# Sundry Print Report
08/26/2023

| **Well Name:** POKER LAKE UNIT | **Well Location:** T24S / R31E / SEC 21 / SESE / 32.196369 / -103.775586 | **County or Parish/State:** EDDY / NM |

## Notice of Intent

**Type of Action:** Plug and Abandonment

# PLU 401H - Proposed WBD

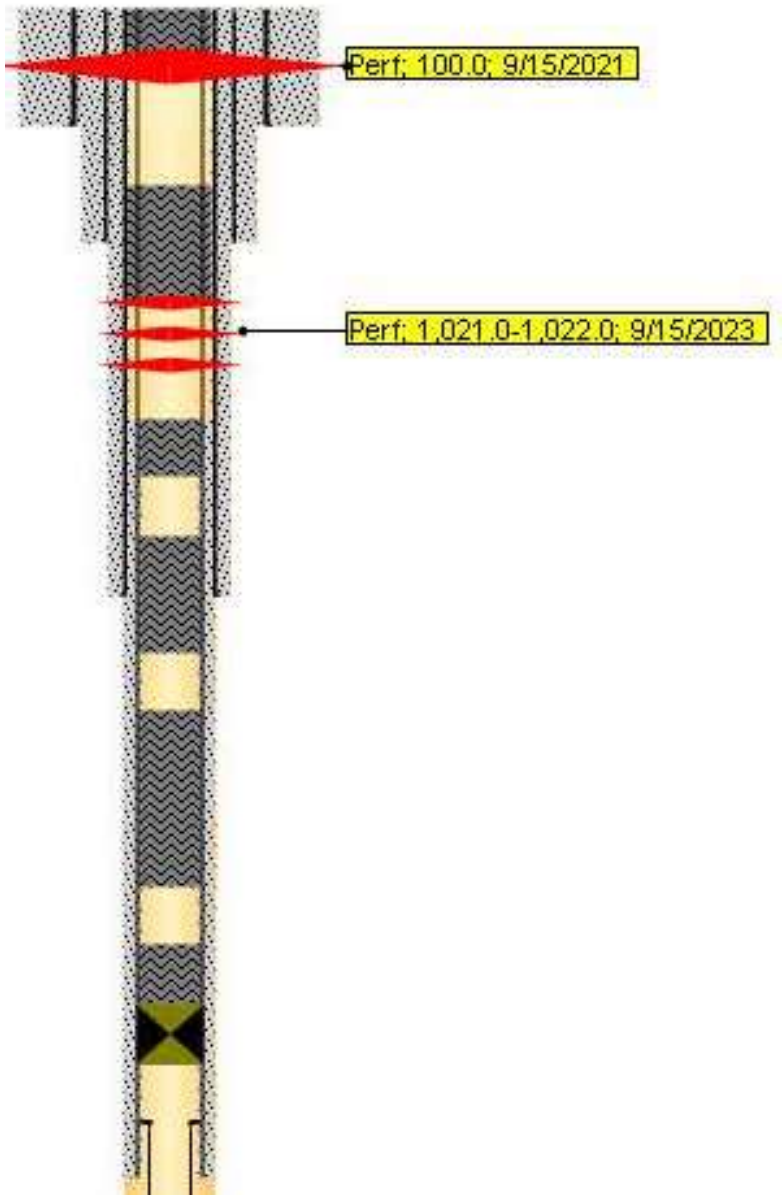
| Plug Type | Top | Bottom | Length | Tag | Sacks | Cement Class | Notes |
| **Surface Plug** | 0.00 | 100.00 | 100.00 | Tag/Verify | 29.00 | C | Perforate and squeeze from 100' to surface. (In 17 sxs/Out 12 sxs) Verify at surface. |
| **Shoe Plug** | 911.29 | 1069.00 | 157.71 | Tag/Verify | 47.00 | C | Perforate and squeeze from 1069' to 908'. WOC and Tag. (In 27 sxs/Out 20 sxs) |
| **DV tool plug** | 4905.94 | 5056.00 | 150.06 | Tag/Verify | 161.00 | C | Spot cement from 5056' to 4068'. WOC and Tag. |
| **CIBP Plug** | 7465.00 | 7500.00 | 35.00 | If solid base no need to Tag (CIBP present and/or Mechanical Integrity Test), If Perf & Sqz then Tag, Leak Test all CIBP if no Open Perforations | 25.00 | C | Tag CIBP at 7500'. Spot 25 sxs on top. Leak test CIBP. |
